## Product Change Notice

(PCN Tracking Number: EE-QR-240425-01)

Customer:	ALL Customers		
Renesas Product Type:	32Mbit/64Mbit SRAM products (please refer to page 2 for complete list)		
Description of Change:	Change of Standby current specification at high temperature		
Reason for Change:	To improve the Standby current specification at high temperature		
Identification:	Identifiable by the Date Code marked on the package (please refer to page 2 for more details)		
Schedules:	Requested approval:	e/o May 2024	
	Change Implementation:	b/o Jun. 2024 onwards	
Anticipated Impact:	Fit, Form & Function:	No impact	
	Quality & Reliability:	No impact	
Doc. No.:	EE-QC-PCN-CR-24-0046		
Internal Reference:	CST-R2-AD211 / PC-APW-A017A/E

### Example of Marking

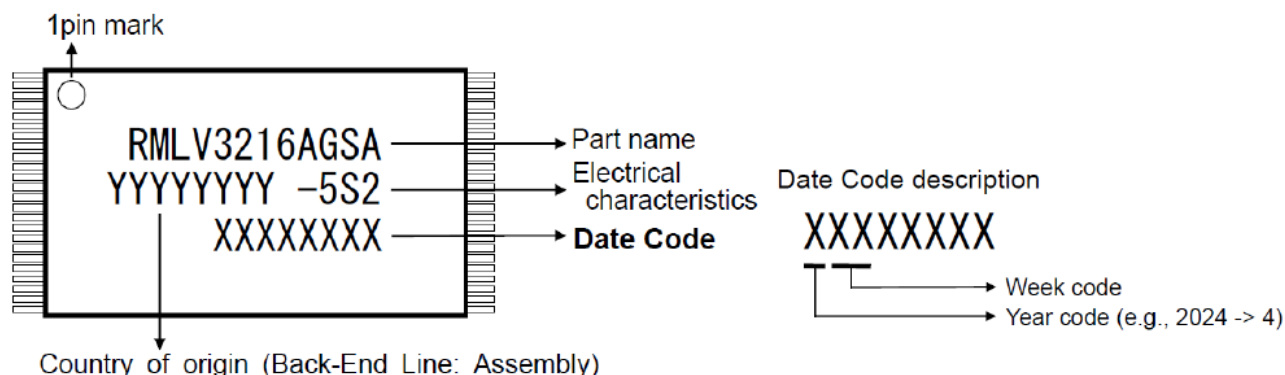
Identifiable by the Date Code marked on the package. Date Code of product after change is starting with 417XXXXX. Please refer below for example of marking and Date Code description.
